Review of Plans: White, 7 Sickletown Road, Pearl River, New York

Item: *White - 7 Sickletown Rd (GML-24-0094)*

**RE: Site Plan Review for Addition and Renovation of Single-Family Residence
7 Sickletown Road in Pearl River, NY
Tax Lot #69.19-1-24; R-40 Zoning District**

PLOT PLAN & NOTES
 NEW SINGLE-FAMILY RESIDENCE
 MR. & MRS. WHITE
 7 SICKLETOWN ROAD
 PEARL RIVER, NY 10965

1 Plot Plan
 G1.02 1" = 20'-0"
 NORTH

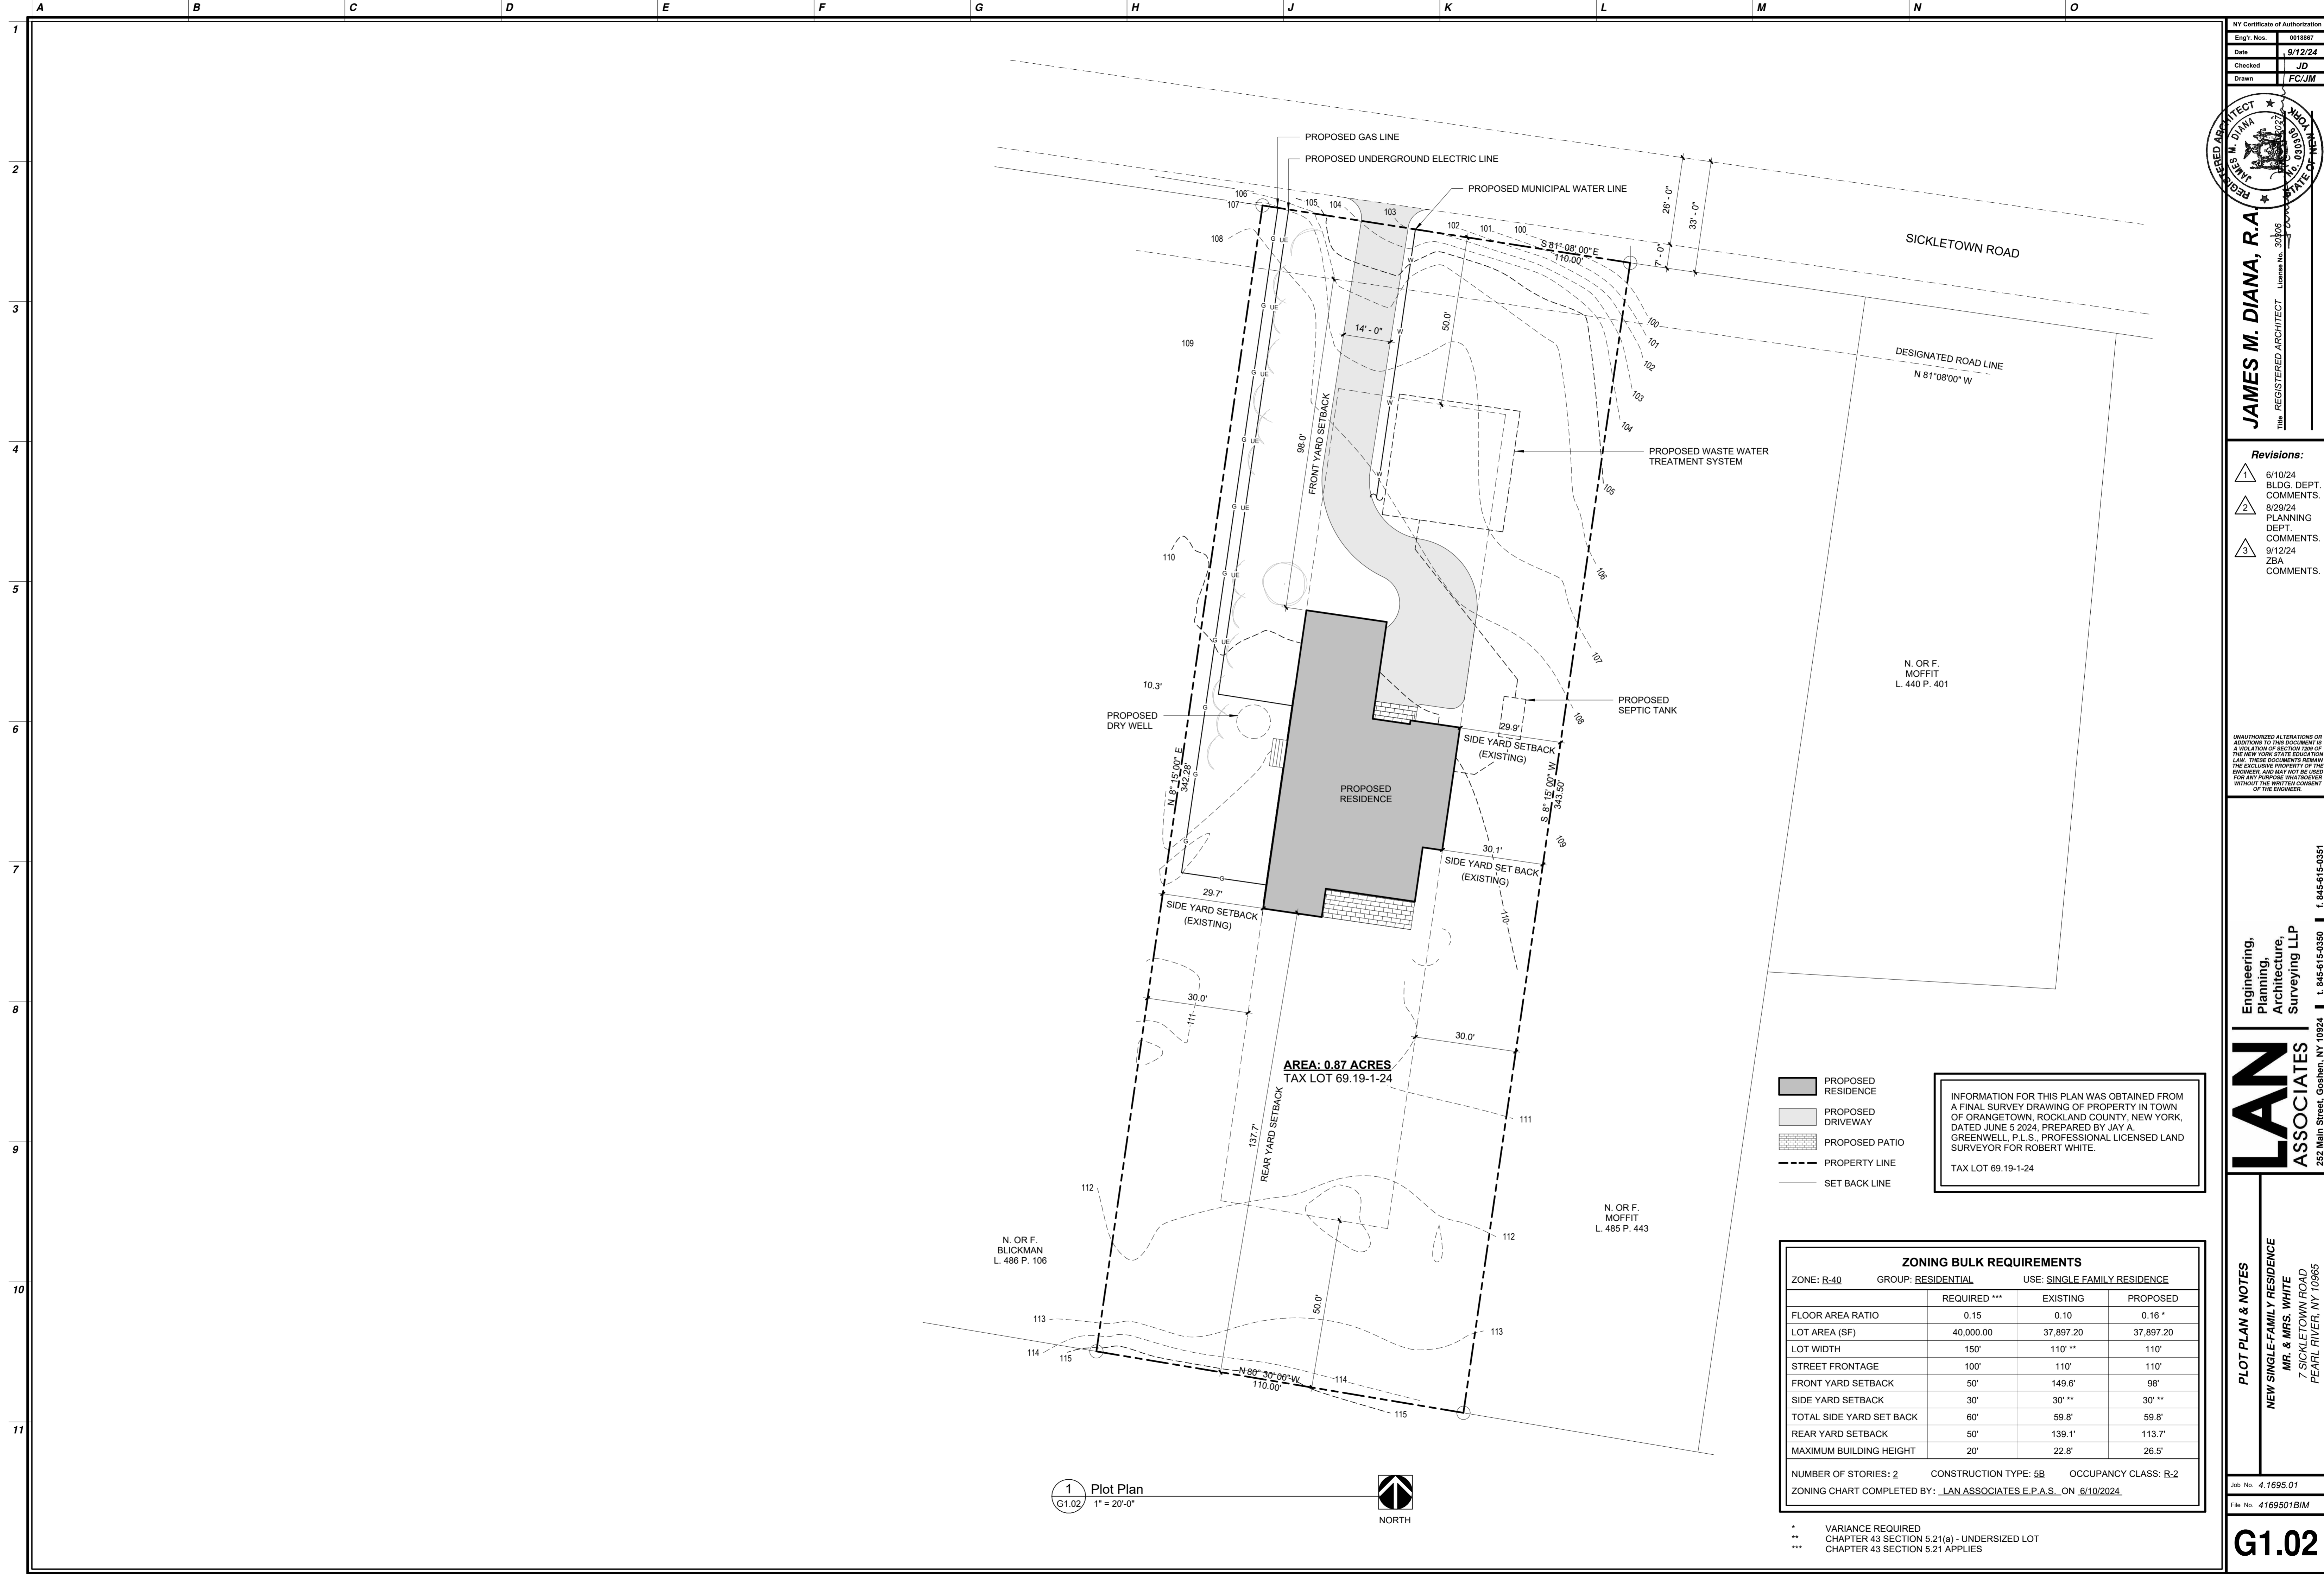
- 4 The Zoning Bulk Requirements table on the site plan indicates that the required total side yard is 80 feet, while the letter from the Office of Building, Zoning, Planning, Administration and Enforcement (OBZPAE) indicates that the required total side yard is 60 feet. The bulk table on the site plan must be revised to reflect the reduced requirements per Section 5.21 and the OBZPAE.

- 5 The Designated Street Line (DSL) must be indicated on the site plan. Per Chapter 43, Article V, Section 5.111 of the Orangetown Code, measurements of the front yard and maximum height requirement shall be to the DSL. The appropriate lot area deductions must also be indicated. Any additional variances required due to a change in measurement must be submitted to this department for review, as required by New York State General Municipal Law, Section 239-m (3)(a)(v).
